BCA Capability Statement

Australian Christian College CASEY
271-275 Pearcedale Road,
Cranbourne South, VIC 3977

Reference: N250189

This statement has been prepared to verify that BM PLUS G Pty Ltd have undertaken a review of the architectural documentation that will accompany the Planning Permit Application to Casey City Council for the proposed Education Centre (Primary and Secondary School) against the Building Code of Australia 2022, Amendment 2 (BCA).

Figure 4: Stage 1 – Distances to existing buildings.

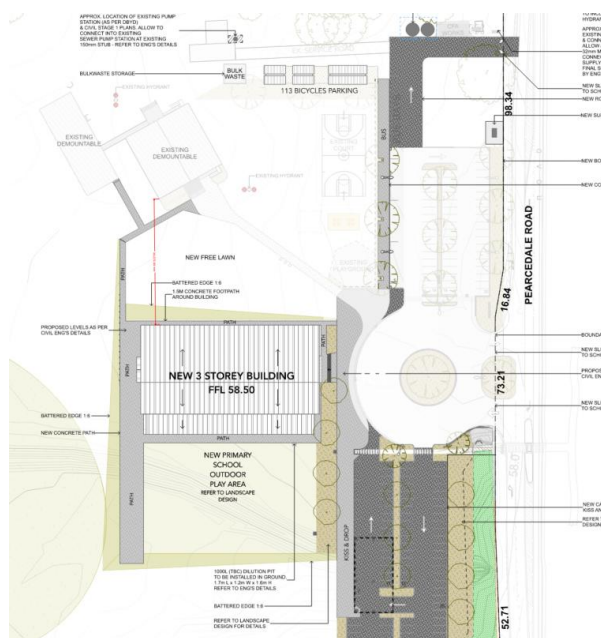
Note: As part of the masterplan the Primary School building is to be connected to the adjacent Tech and Secondary School buildings in Stages 3 and 4, creating a Large Isolated Building – no other buildings are to be constructed as part of Stage 1.

Figure 7: Distance between buildings

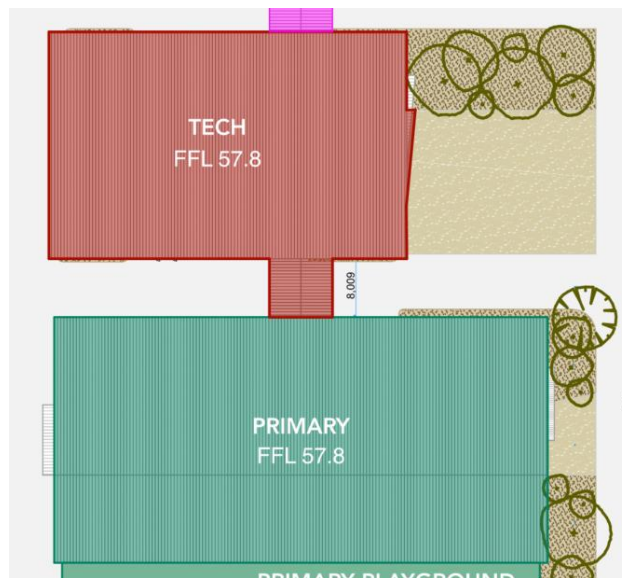
For the purpose of the current BCA assessment, we note that all buildings proposed in the masterplan may be deemed separate united buildings where connected via a linkway pending design refinement and buildings being separated by 6m or more.

Based on a review of the documentation to date we note that compliance will be achieved with all buildings shown to be below the maximum compartment sizes under this clause.

Figure 8: Future link bridge connections

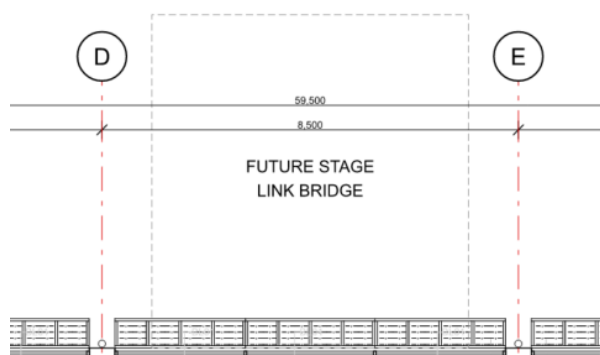
The current design for stage 1 does not require any fire walls, with the future connection to other buildings to be assessed as a single Large Isolated building under the BCA.

Figure 10: Non-fire isolated stairway connecting three (3) storeys

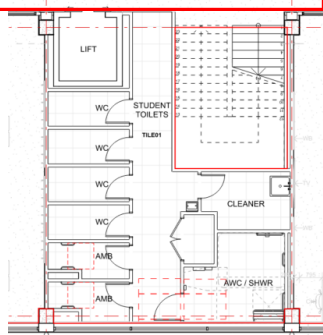
Comment: Compliance is not achievable. The non-fire isolated stairways connects three storeys which is permitted where the building is sprinkler protected throughout.

Figure 11: Ground Floor - Distance between alternate exits

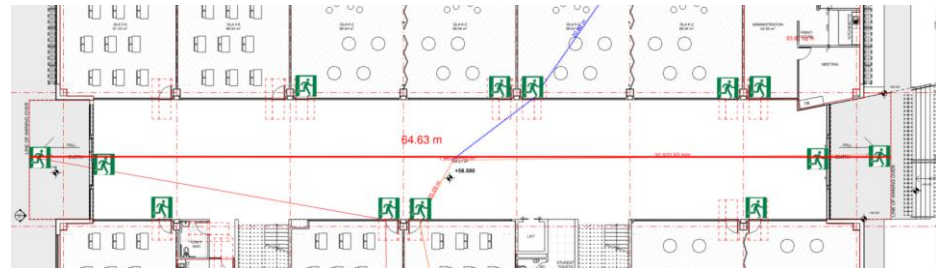
Comment: Does not comply / Performance Solution.

Shortfalls may be addressed under a fire engineering strategy with consideration of installing an automatic fire detection and alarm system is installed throughout the building.

Figure 14: Egress path to the road from open space.

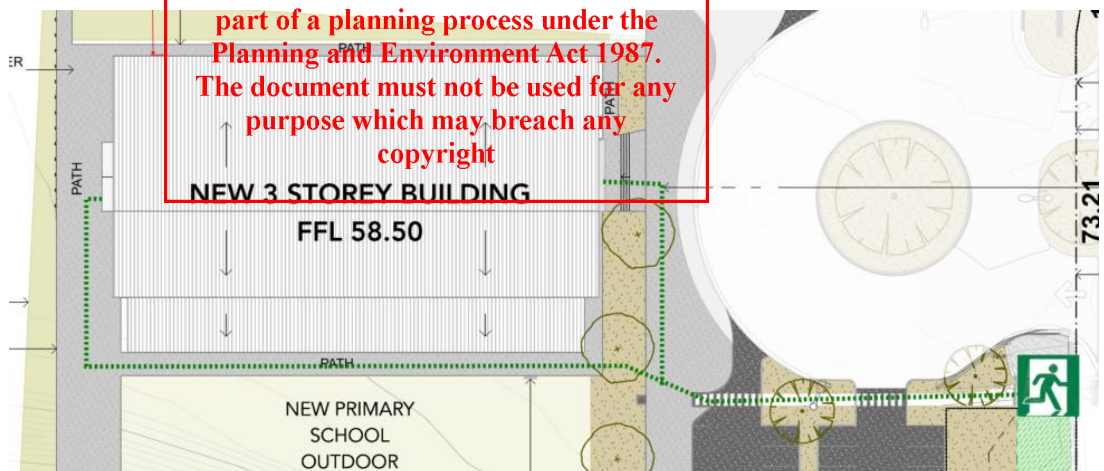
Where ramps or walkways are proposed along the paths of travel to the road compliance is to be achieved with AS1428.1-2021 where serving an accessible path.

External egress paths must be open to the sky for its length, from the point of discharge, to without necessitating passing underneath another structure – such as a covered walkway or building, where proposed this will need to be addressed under a fire engineered Performance Solution strategy.

Figure 14: Non-fire isolated stairways without staggered flights

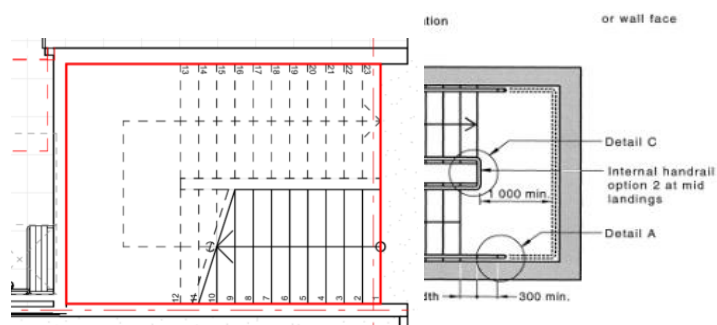
Particular attention needs to be paid to any of the primary school parts or areas where the primary school users will have access, where dual handrails will be required.

The stairway is to be provided with a staggered flights to achieve compliance with AS1428.1-2021, with regards to handrail transitions at mid-landings.

Figure 16: Staff Amenities

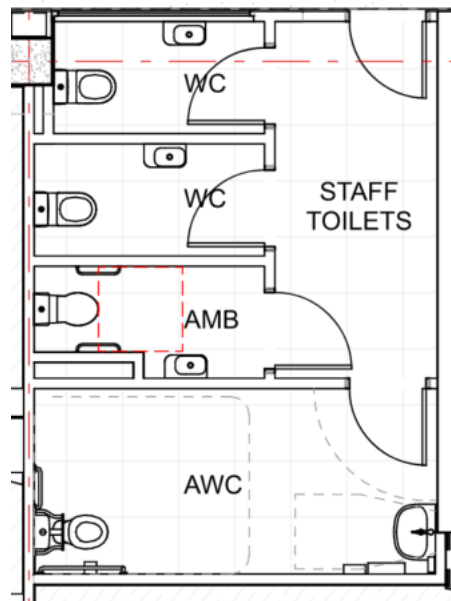
Comment: Performance Solution.

The staff bank of toilets on Levels 1 and 2 are shown to be provided with a single ambulant facility at an accessible bank of toilets in lieu of separate male and female ambulant facilities to comply with F4D5 (c) – where proposed to remain it may be addressed under Performance Solution.

Figure 16: Room Heights

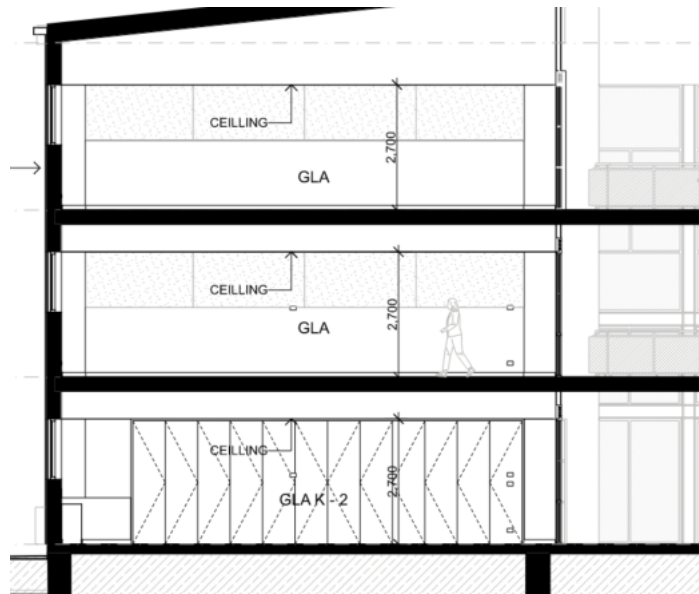
The unobstructed ceiling height is shown to be not less than 2.7m, including circulation areas.

Figure 17: Atrium/Void connecting three storeys

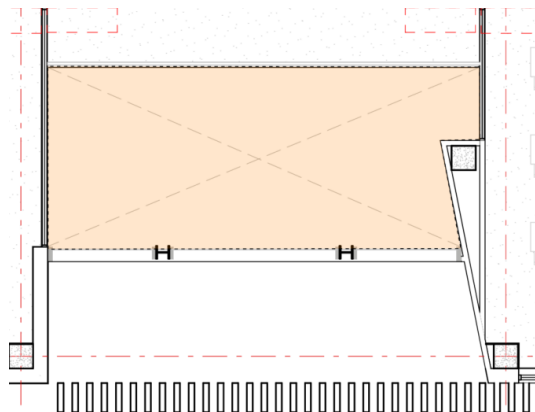
The building is proposed to be sprinkler protected, on this basis the atrium/void connecting three storeys is permitted.

Figure 18: Bushfire Management Overlay

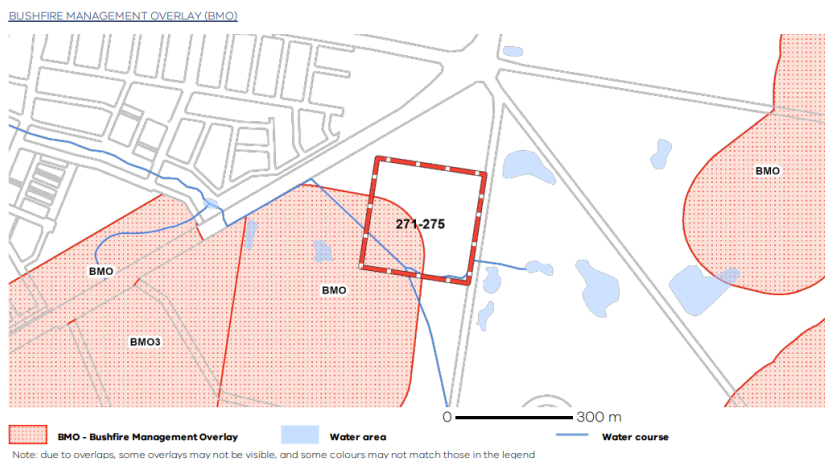
Comment: Further information required/Performance Solution.

Note: There are no DTS compliance pathways available for a site having a BAL rating of 12.5 or more where greater than 12.5 then the current works will be subject to a Performance Based strategy. This strategy will be reliant on various quantitative calculation methods, operational requirements and onsite refuge utilising DTS requirements as a benchmark.

Further consultation with the projects fire safety engineer and bushfire consultant will be required in this regard.

Figure 19: Carpark Setback

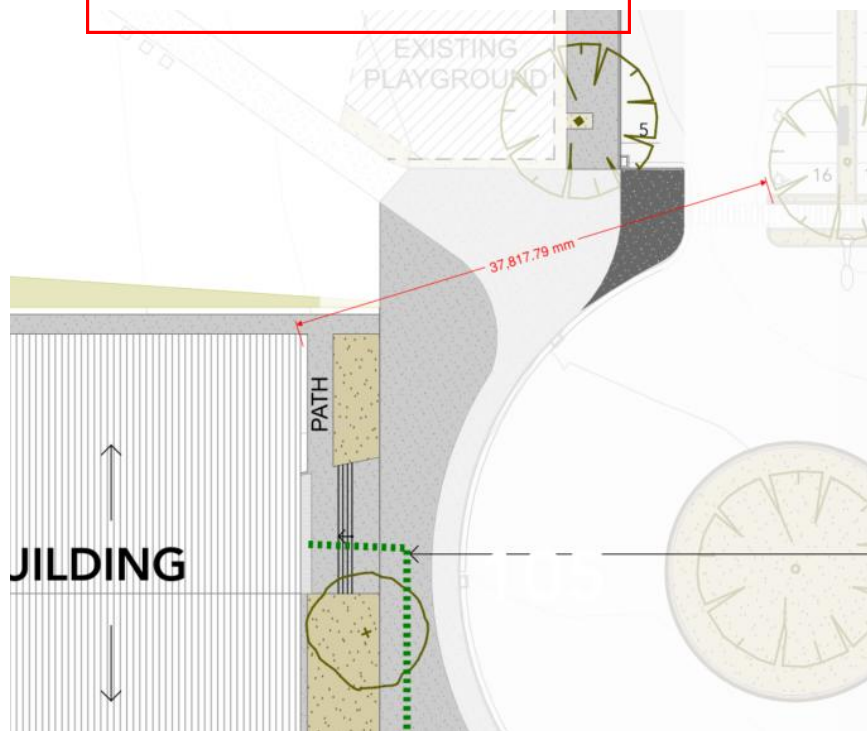
The works maintain generally a 10m setback from any carparking areas based on the current design – for future staging drop off areas are to be considered to be carparking spaces.

+ Appendix A – Exit Locations + Egress Paths

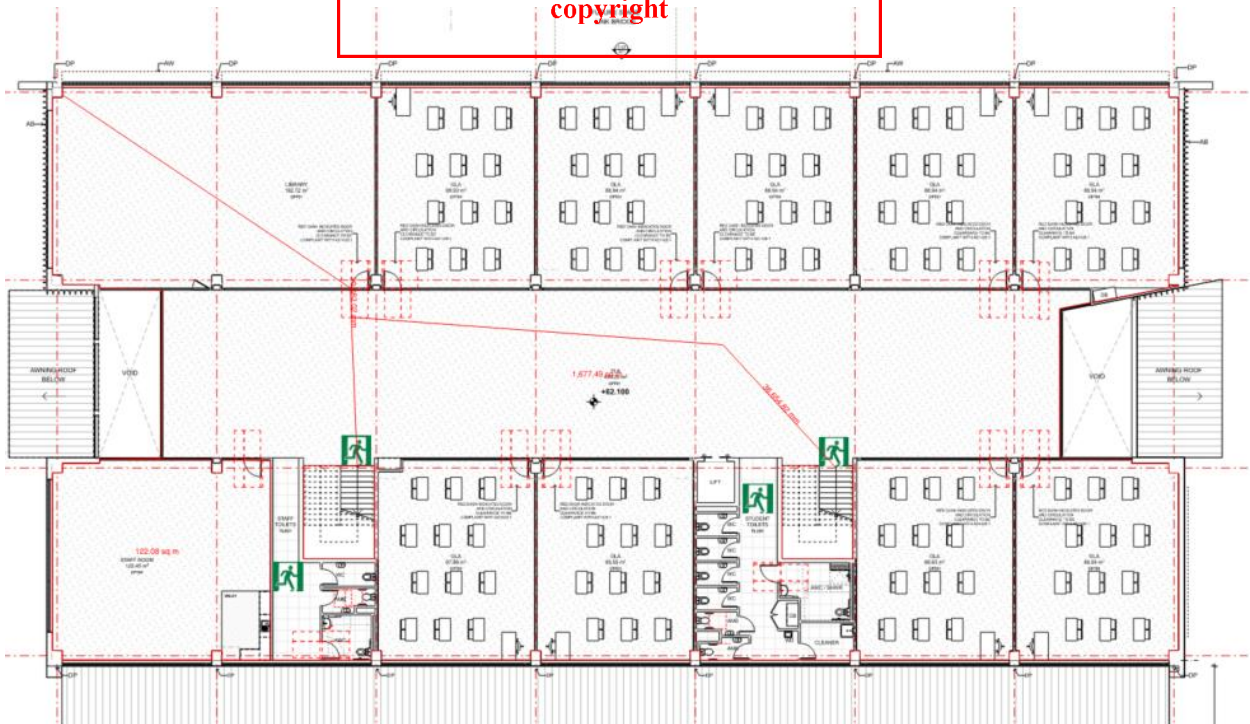
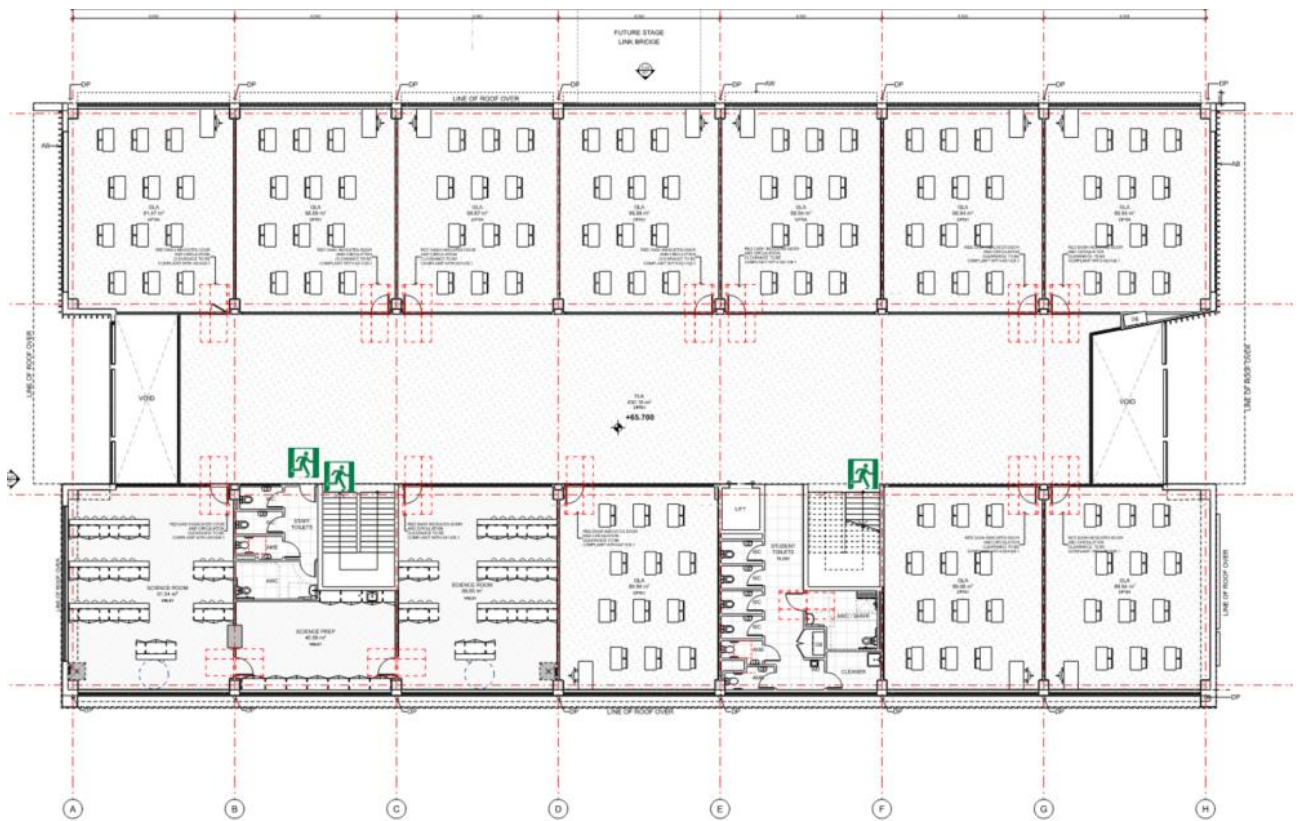
Refer to egress markups in Appendix A of this report.
